Subject: **CORRECTING CLICKING NOISE**

Model: **BKM-102**

Serial No: **2,000,060–2,000,328**

Figure 1

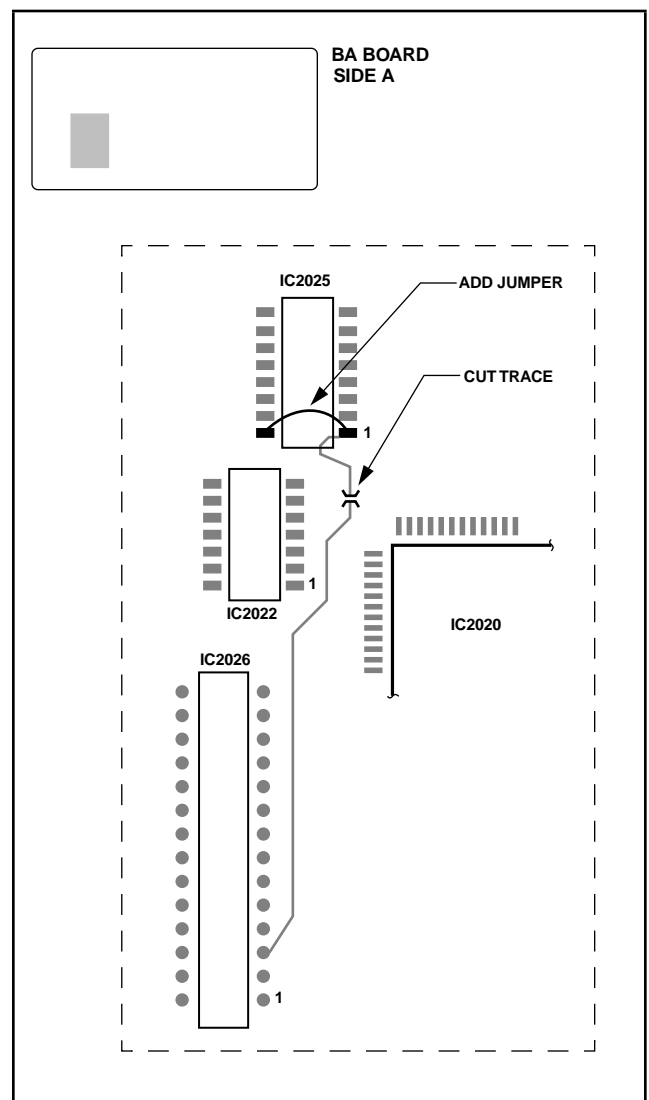
When feeding a signal from Tektronix signal generator TSG-601 to the SDI input of a PVM-1954Q with a BKM-101C/BKM-102 installed, a clicking sound may be heard. To correct this condition, perform the following modification procedure.

1. Cut trace leading from pin 3 of IC2026 (PLD) (zone F-2).
2. Solder a jumper between pin 1 (clear) and pin 16 (+5V) of IC2025 (counter) (zone D-2) as shown in Figure 1.
